World Forum for Harmonization of Vehicle Regulations

Working Party on Passive Safety

Global technical regulation No. 9 (Pedestrian safety)**Proposal for Corrigendum 2 to global technical regulation No. 9****Submitted by the experts from the European Commission and the Republic of Korea***

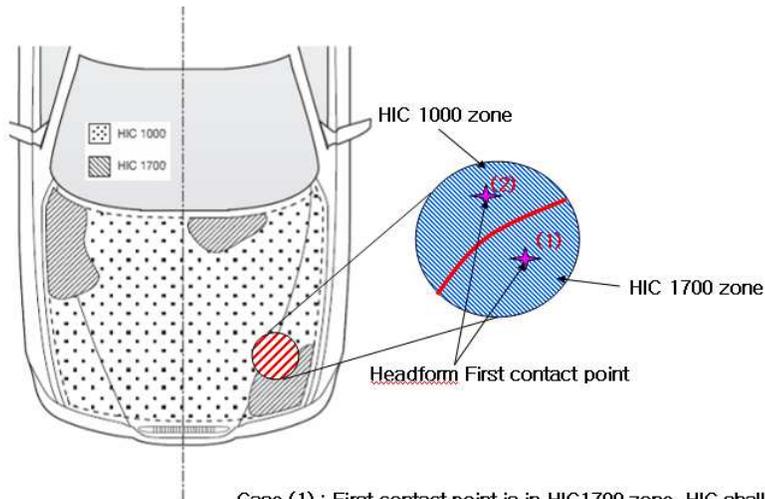
The purpose of these amendments is to clarify requirements when a headform impact test is carried out according to the test procedure of paragraphs 7.3 and 7.4. The impacted zone on the bonnet is that which is first contacted by the headform.

Case (1) : First contact point is in HIC1700 zone, HIC shall not exceed 1700
Case (2) : First contact point is in HIC 1000 zone, HIC shall not exceed 1000

“5.2.4.3. The areas of “HIC1000 Zone” and “HIC1700 Zone” may consist of several parts, with the number of these parts not being limited. **The determination of the impacted zone is done by the first contact point of the headform with the “bonnet top.”**”
